Technical Service Bulletin

NUMBER: 23-26-99

Rattle Noise At The Sliding Door Upper Track Or B-Post Area.

1996 – 1999 (NS) Town & Country/Caravan/Voyager
1996 – 1999 (GS) Chrysler Voyager (International Market)

1. ADJUSTING BOLT
2. WELD NUT

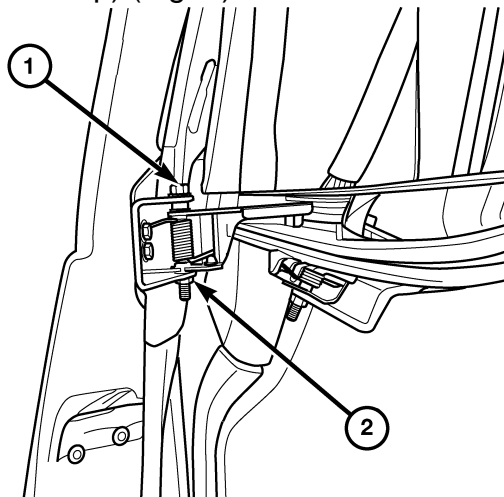
- a. Check the gaps at the front and rear of the sliding door.
- b. If the sliding door gaps are out of specification;
 - (1) Open the door to mid-point of travel.
 - (2) Mark outline of center hinge on sliding door to assist in making adjustments.
 - (3) Loosen center hinge bolts (Fig. 1).
 - (4) Move hinge forward to reduce the gap or rearward to increase the gap at the rear of the sliding door.
 - (5) Tighten center hinge bolts, 12 Nm (105 in. lbs.).
 - (6) Verify alignment. Re-adjust as necessary.

- a. Visually inspect the sliding door for fit at the rear of the door by checking the alignment of the belt line of the door to quarter panel.
- b. If the alignment is out of specification;
 - (1) Fully open the sliding door.
 - (2) Verify that all center hinge bolts are tight, 12 Nm (105 in. lbs.).
 - (3) Adjust the rear of the sliding door (turn the center hinge bolt clockwise to move the door up) (Fig. 1).

FIGURE 2

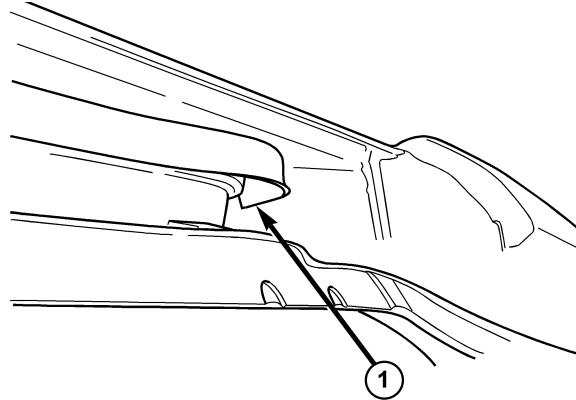
- 11. Check for UHMWPE tape on the inside of the upper track downstanding flange (where the upper hinge roller parks when the door is closed) (Figure 2). If the tape is present, verify that it is still intact. If the tape is torn, replace it with a new piece of tape, p/n 05017430AA. Clean the flange with isopropyl alcohol before applying the tape. The tape should be placed on the downstanding flange of the track so the end of the tape is flush with the front end of the track flange and the edge of the tape is as close to the top of the downstanding flange as possible.

1. APPLY TAPE ON INSIDE SURFACE AT FRONT EDGE OF TRACK FLANGE
